HISTORIC AND DESIGN REVIEW COMMISSION

May 04, 2022

HDRC CASE NO: 2022-087
ADDRESS: 100 TAYLOR ST
LEGAL DESCRIPTION: NCB 430 BLK 8 LOT 11
ZONING: D, H, RIO-3
CITY COUNCIL DIST.: 1
LANDMARK: Individual Landmark
APPLICANT: Paula Price/Batir Architecture
OWNER: Carlos Oliveira/H5 DATA CENTERS - SAN ANTONIO LLC
TYPE OF WORK: Enclose breezeways, installation of a 7' tall rear fence, window tinting, utility installation
APPLICATION RECEIVED: April 11, 2022
60-DAY REVIEW: Not applicable due to City Council Emergency Orders
CASE MANAGER: Hannah Leighner
REQUEST:

① SITE PLAN
1/16" = 1'-0"

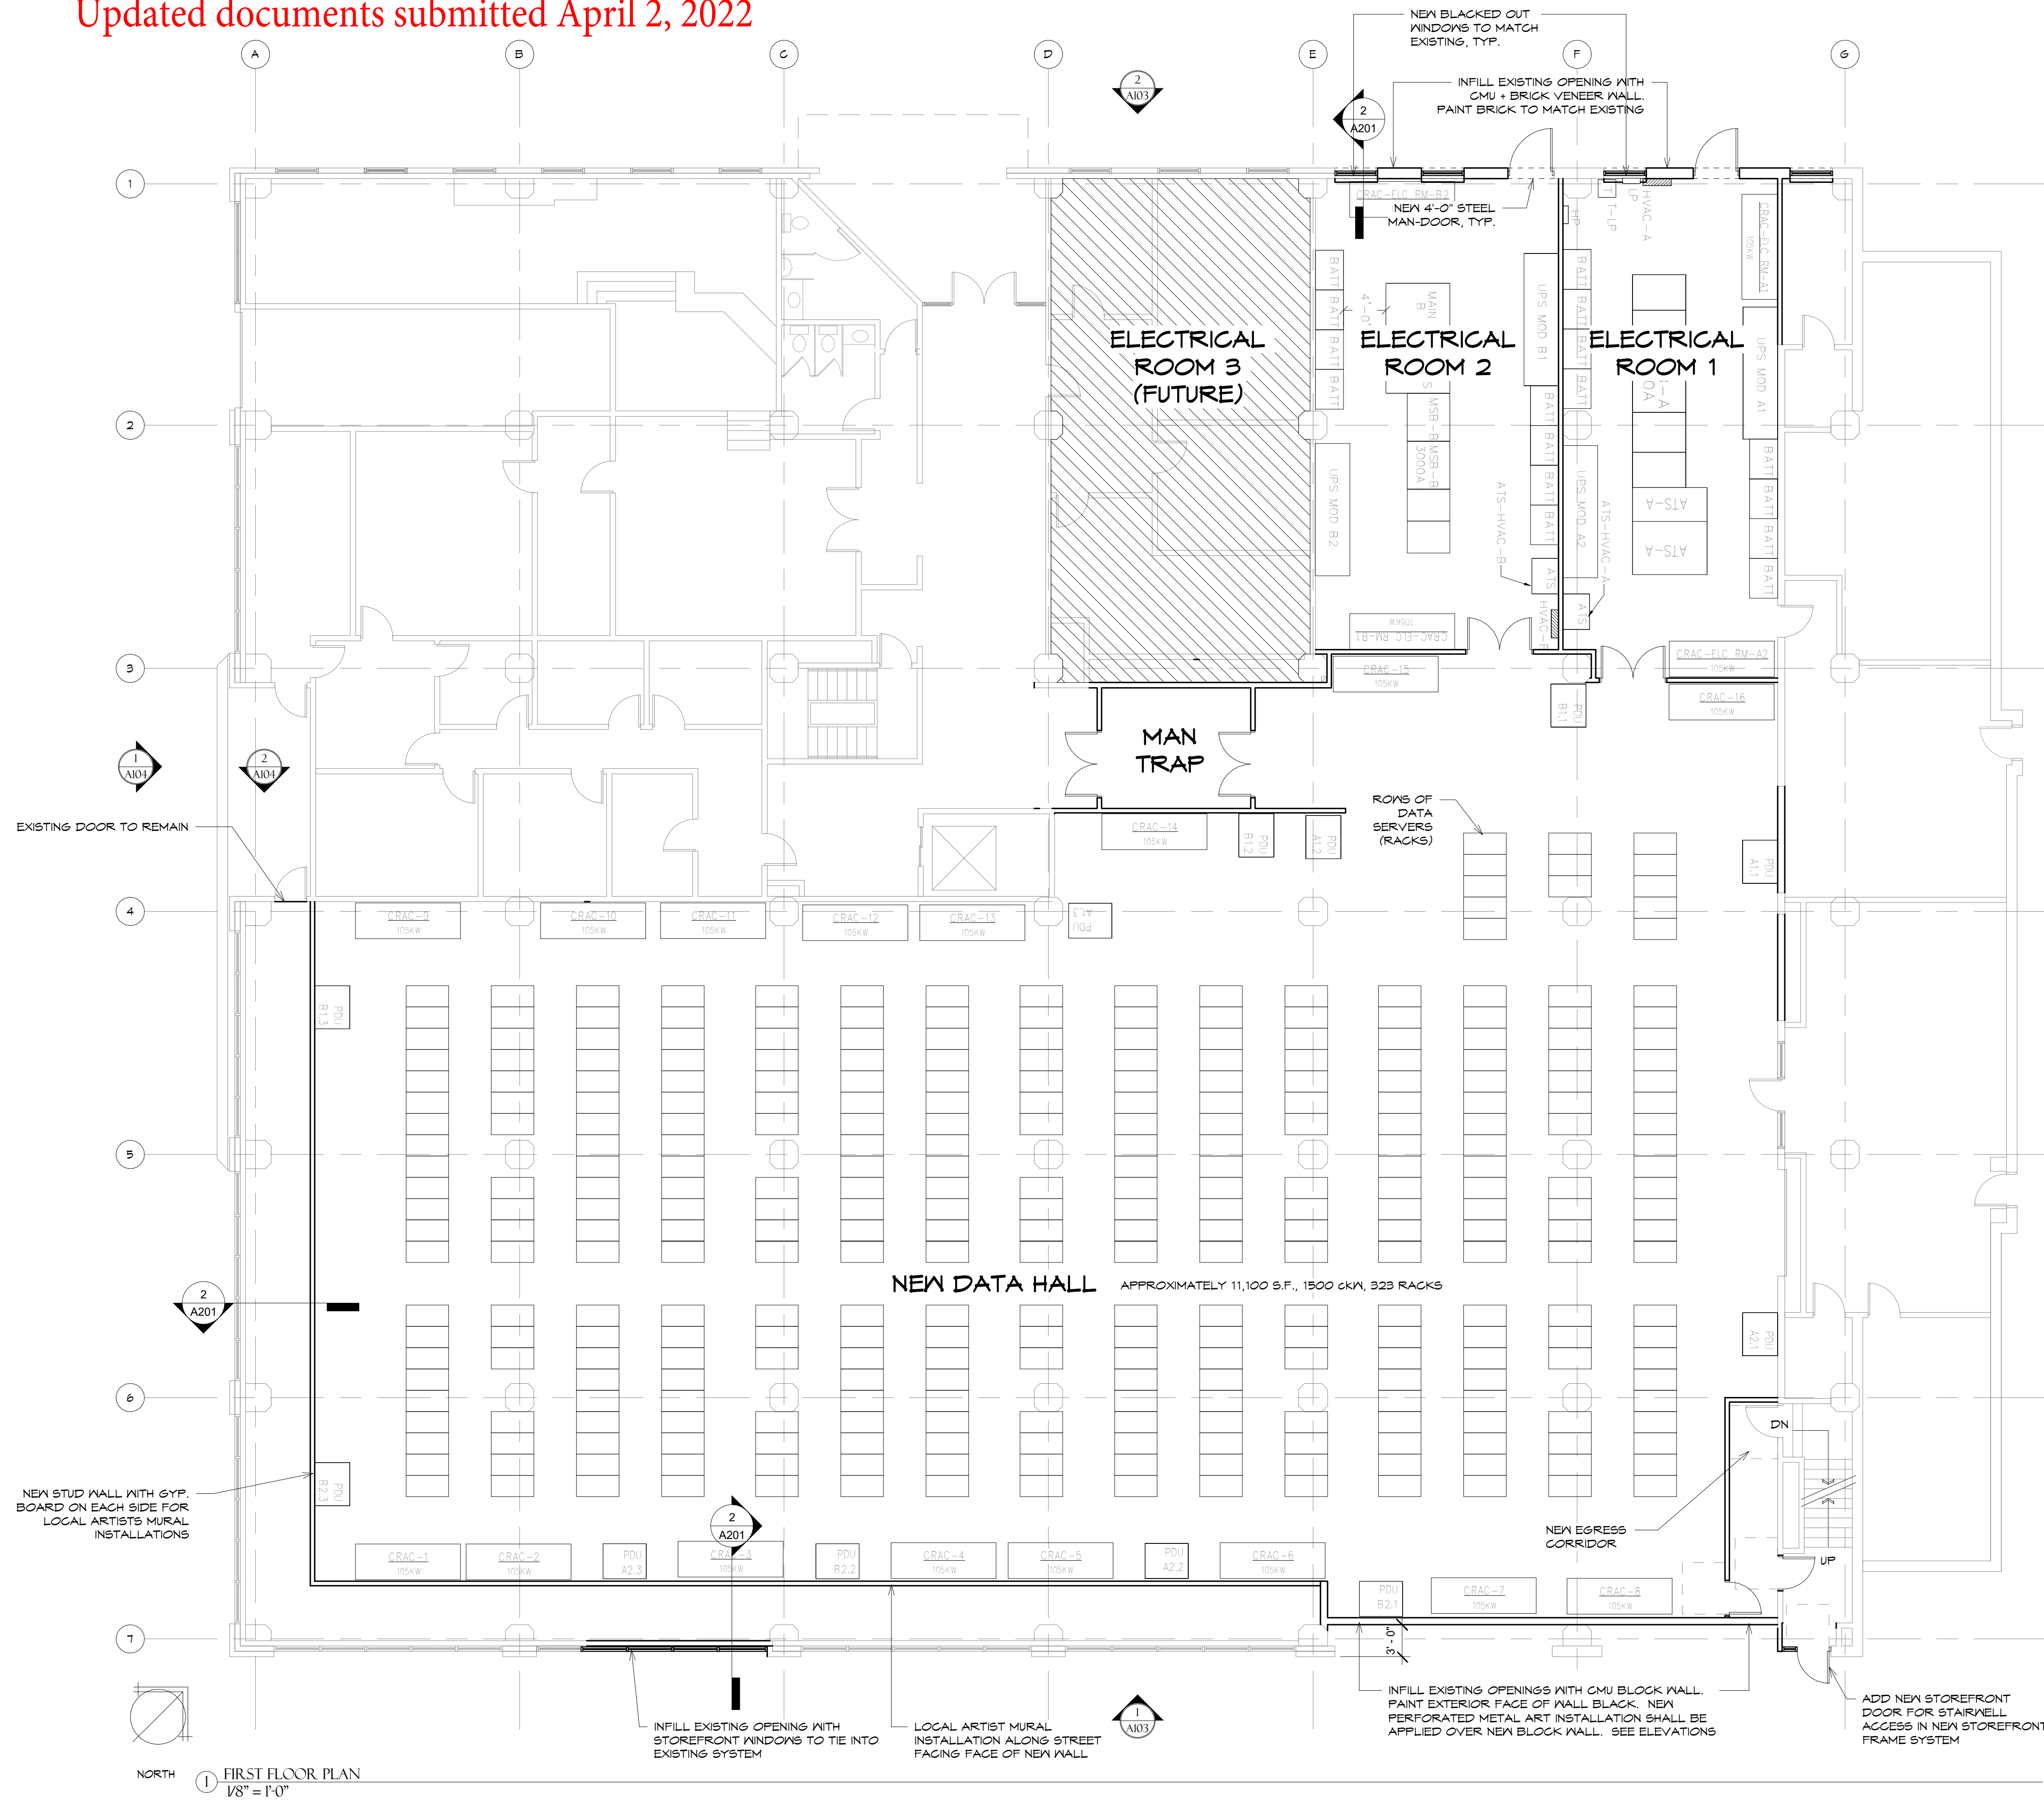
- c. **UTILITY INSTALLATION** – The applicant is requesting to install utility generators and transformers in the rear of the structure at the northwest corner of the property, which will be surrounded by new fencing. The Historic Design Guidelines for new construction 6.B.ii recommend that new mechanical equipment should be installed out of direct view from the right-of-way, and should be obstructed using a fence, hedge, or other enclosure. Staff finds that the location of the utilities installation to be consistent with these guidelines.

- g. **FENCE INSTALLATION** – The applicant is proposing to install approximately 54 linear feet of new fencing around the new utility power infrastructure area. The fencing is proposed to match the existing brick wall fencing, and be 7' ¾" in height. The OHP Fence Policy guidelines states that rear privacy fences should not exceed 6 feet in height. Staff finds the installation of the proposed fence to be appropriate to obstruct the utility equipment, however recommends that the fence not exceed 6 feet.

1. Staff recommends approval of item #1, the installation of rear mechanical equipment with the stipulation that all equipment be screened by fencing, not to exceed six (6) feet in height.
2. Staff does not recommend approval of item #2, the enclosure of existing breezeways, as noted in finding c. Staff recommends these breezeways remain open and unaltered. If the HDRC is compelled to approve and enclosure, staff recommends that any permanent infill walls be set back within the opening and be distinguishable from the street wall.

3. Staff recommends approval of item #3, modifications to one storefront bay, its entrance, and stone façade based on finding d.
4. Staff does not recommend approval of item #4, the installation of black out window tint, as noted in finding e.
5. Staff recommends approval of item #5, the installation of rear fencing, based on finding f, with the stipulation that fencing does not exceed six (6) feet in height.

FIRST FLOOR PLAN

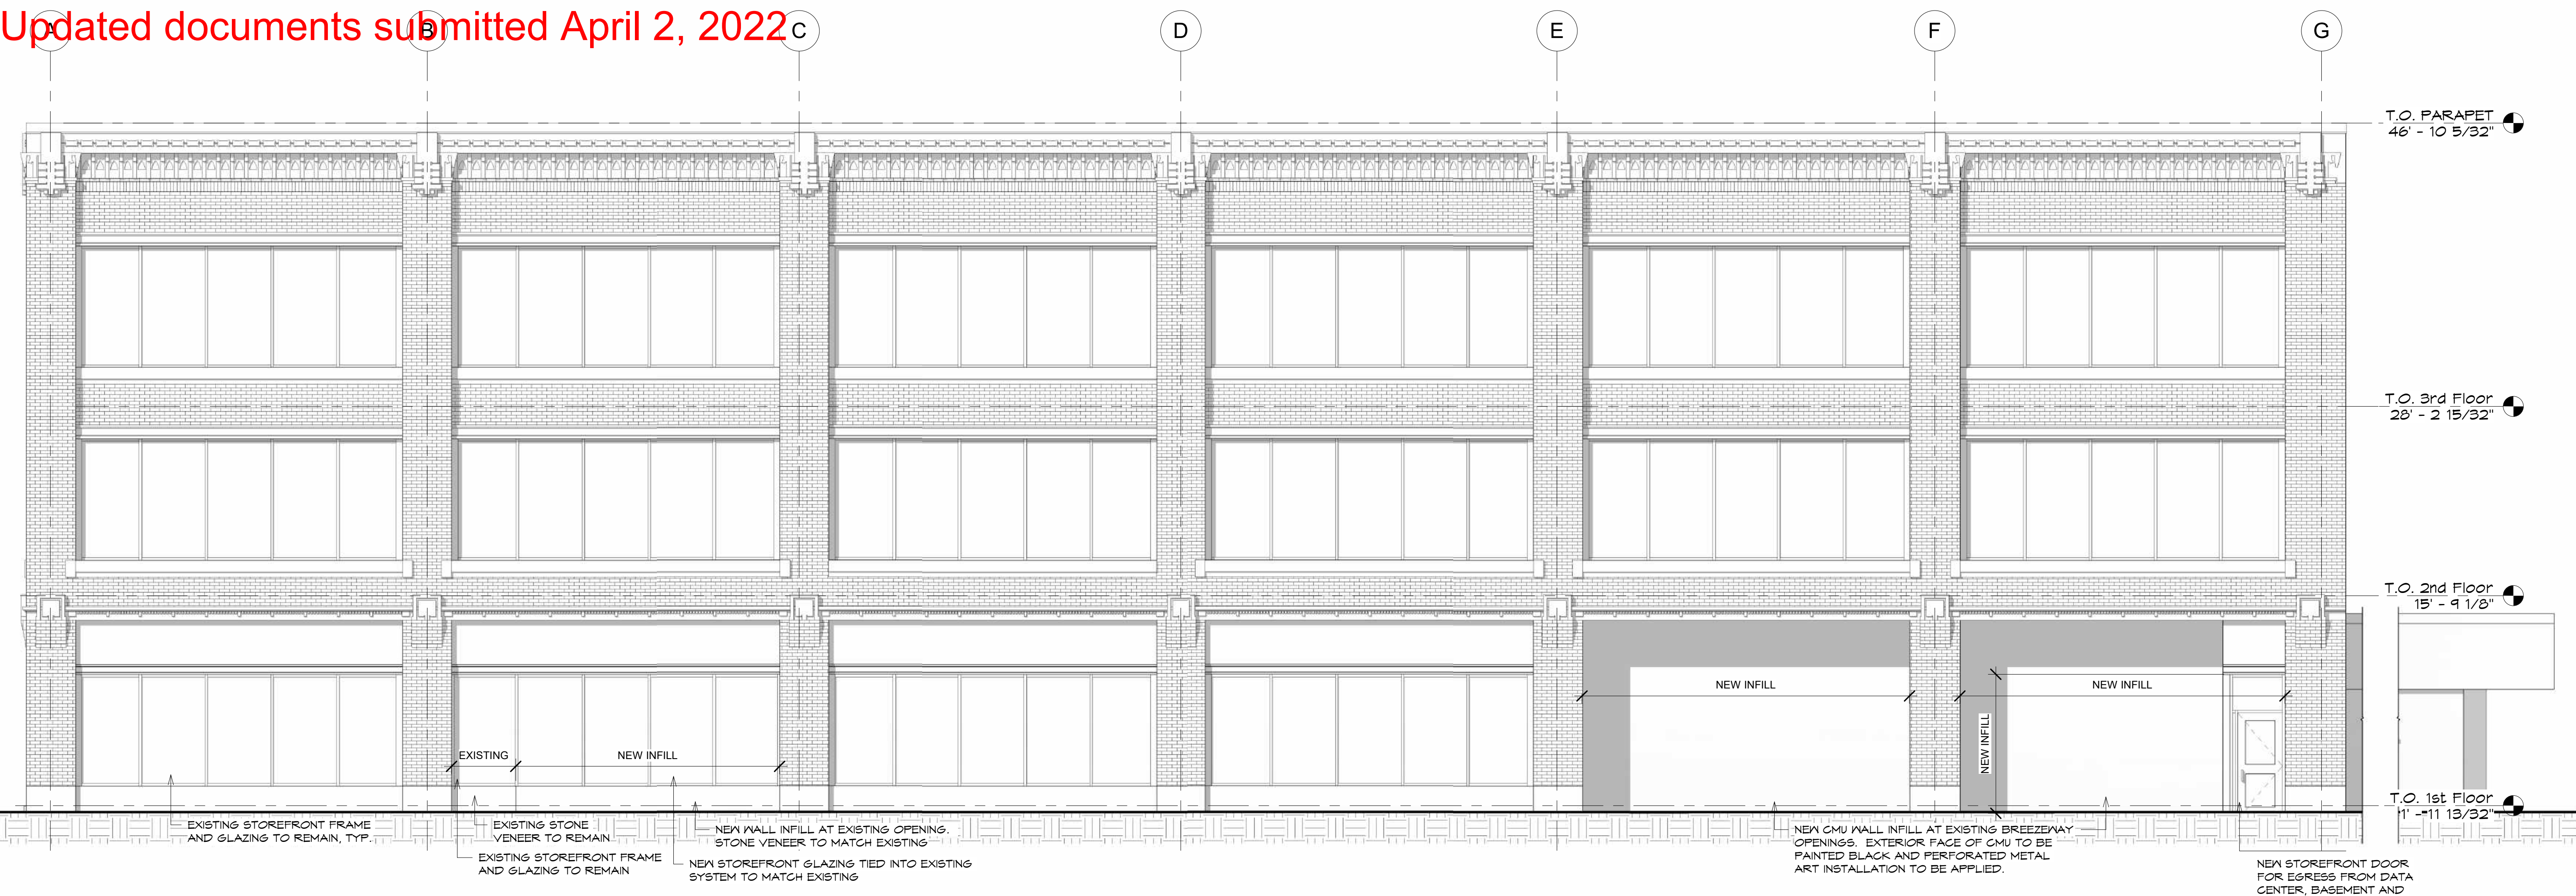
- d. **BREEZEWAY ALTERATIONS** – The applicant is requesting to enclose the existing breezeways connecting Broadway to the rear of the structure. As noted in finding a, these breezeways are considerable character-defining features of the structure, as historically significant components to the commercial façade of a former auto sales and repair facility; The far right-hand breezeway is pictured as existing as early as 1920. The Guidelines for Exterior Maintenance and Alterations 10.A.i. states to preserve character-defining features such as entryways and other features that contribute to the character of the building. The Guidelines for Exterior Maintenance and Alterations 6.A.i. also states to preserve existing window and door openings, and to avoid filling in historic door or window openings and to avoid creating new primary entrances or window openings on the primary façade or where visible from the public right-of-way. Additionally, the Guidelines for Exterior Maintenance and Alterations 10.B.i. state to not introduce new facade elements that alter or destroy the historic building character, such as adding inappropriate materials; altering the size or shape of windows, doors, bulkheads, and transom openings; or altering the façade from commercial to residential. Alterations should not disrupt the rhythm of the commercial block. The structure at 100 Taylor fronts Broadway and is neighbored by similar commercial buildings and store front facades. Staff does not find the proposed modifications to the existing breezeways to be appropriate; staff recommends that the original openings and breezeways remain unaltered.

2 TYPICAL BLACKED OUT WINDOW
DETAIL
3/4" = 1'-0"

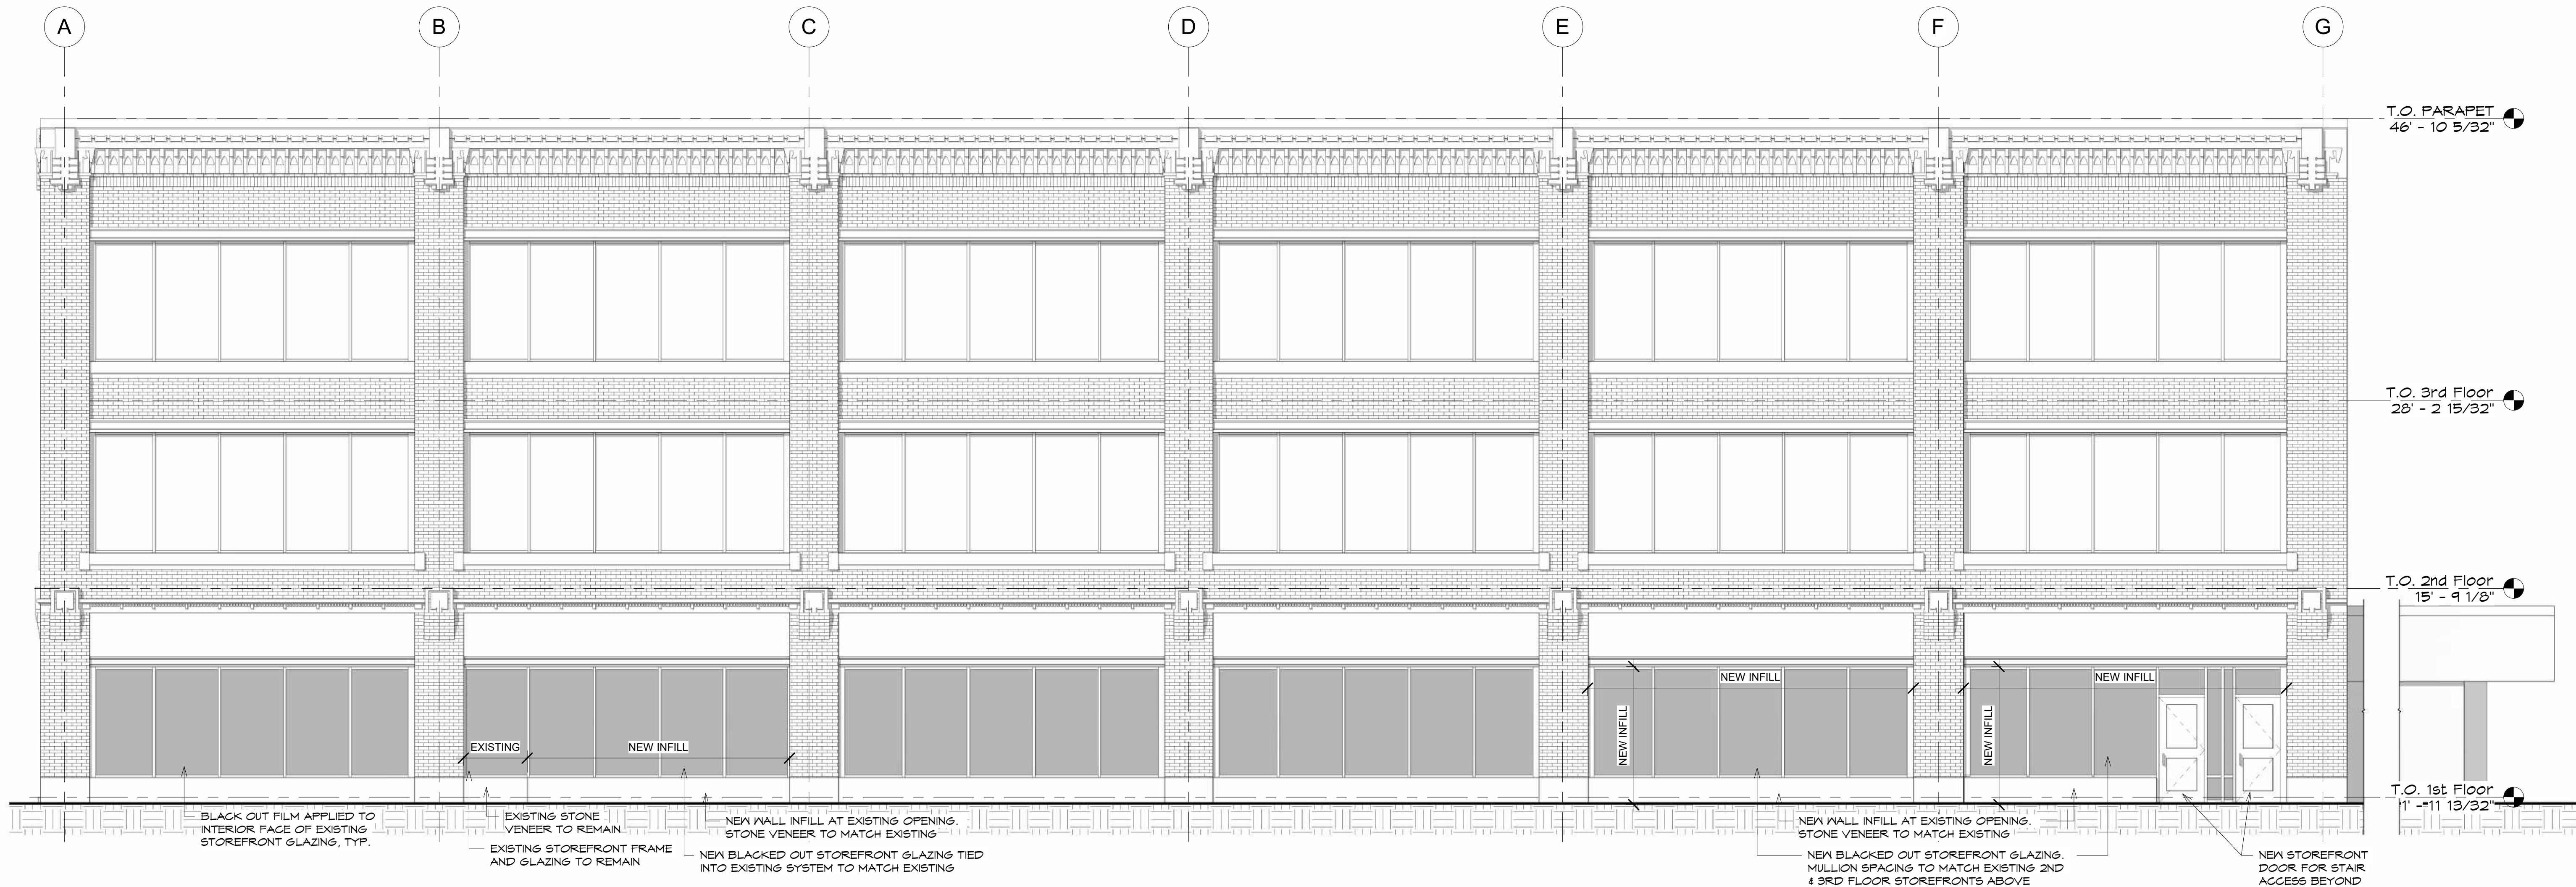
- f. **WINDOW TINTING** – The applicant is requesting to apply black-out tinting to the existing windows. The Historic Design Guidelines for exterior alterations 6.A.iii. recommends to preserve historic windows, and to maintain clear glass. Staff does not find the proposed black-out window tinting to be consistent with the guidelines.
